SUBJECT : ImageQuest Co., Ltd.
FCC ID: PJIL17A0D080
Class II Permissive Change
Orig. Grant Date: March 12, 2003

Transmitted herewith, on behalf of ImageQuest Co., Ltd. is an application for a Class II Permissive Change Certification of the following 17-inch LCD Monitor:

FCC ID : PJIL17A0D080
Model/Type : L70S/L17A0D080

The device is identical to the previously certified monitor except for the following:

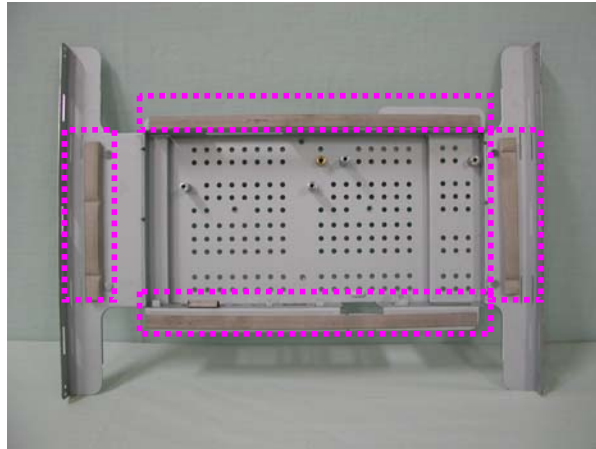
1. Attach a gasket on the Main Frame to contact a LCD panel

2. Attach a copper foil between Main Frame and LCD panel

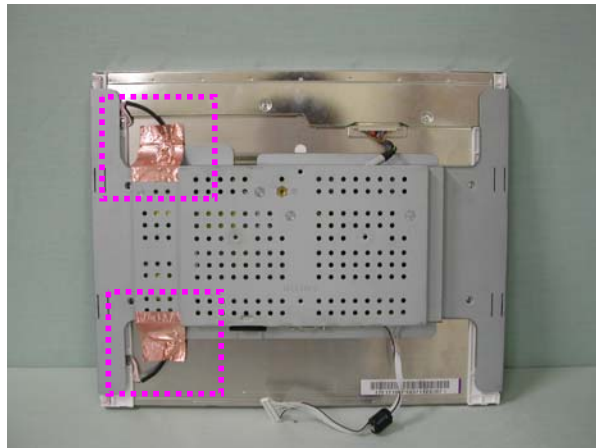
4. Apply a ferrite Core to the OSD board signal cable
